From: DUNCAN Leslie E (AREVA NP INC) [Leslie.Duncan@areva.com]
Sent: Thursday, February 25, 2010 2:23 PM
To: Tesfaye, Getachew
Cc: DELANO Karen V (AREVA NP INC); BENNETT Kathy A (OFR) (AREVA NP INC); ROMINE Judy (AREVA NP INC); KOWALSKI David J (AREVA NP INC); BRYAN Martin (EXT)
Subject: Response to U.S. EPR Design Certification Application RAI No. 329, FSAR Ch. 10 OPEN ITEM
Attachments: RAI 329 Response US EPR DC.pdf

Request for Additional Information No. 329 (3824), Revision 1
11/16/2009
U.S. EPR Standard Design Certification
AREVA NP Inc.
Docket No. 52-020
SRP Section: 10.02 - Turbine Generator
Application Section: 10.2

Question 10.02-7:

Figure 10.2-2—Overspeed Protection System Schematic

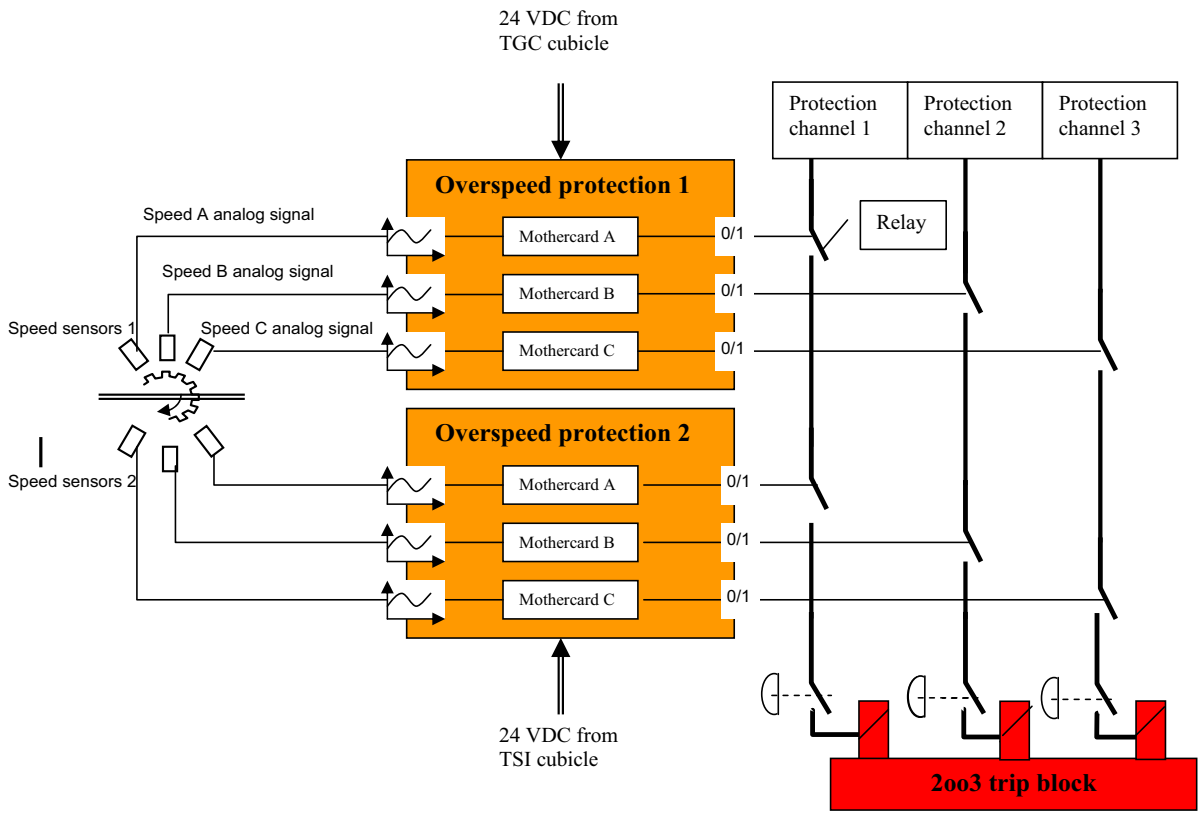
In accordance with 10 CFR 52.47(a), the NRC staff also requests that the applicant revise the U.S EPR FSAR to include the two below listed figures provided in the response to Request for Additional Information No. 243 (2991), Revision 0, Question 10.02-6:

Figure 10.02-6-1—Overspeed Trip System Schematic

U.S. EPR FSAR Tier 2, Section 10.2.2.9 will be revised to include the following new figures showing the schematic of the overspeed protection system and turbine trip block:

- U.S. EPR FSAR Tier 2, Figure 10.2-2—Overspeed Protection System Schematic.
- U.S. EPR FSAR Tier 2, Figure 10.2-3—Turbine Trip Block Schematic.

Figure 10.2-3—Turbine Trip Block Schematic

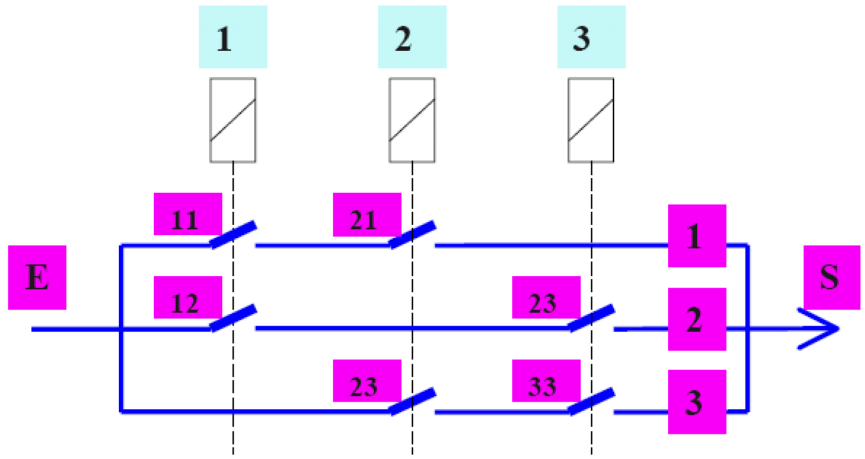
Figure 10.02-6-2—Turbine Trip Block Schematic

The trip block provides an interface between the electrical and hydraulic systems and consists of three trip solenoid valves. The three independent electronic channels energize three fail safe solenoid valves (trip by loss of power). Each solenoid valve acts on two hydraulic relays of the trip block in order to perform the hydraulic two-out-of-three trip voting. The turbine will be tripped when a least two solenoid valves are de-

energized. An interruption and discharge of the fluid supply by the trip block will cause the high pressure and intermediate pressure valves to close by spring action. Figure 10.2-3—Turbine Trip Block Schematic provides a schematic of the trip block. Failure of the hydraulic tubing between the trip block and the valve actuator, or between the hydraulic fluid tank and the valve actuator will cause a loss of fluid pressure, which closes the valves. Thus, the trip block is designed fail safe, due to the fact that any failure (e.g., loss of power, loss of safety fluid pressure, fluid leak) will cause a steam turbine trip.
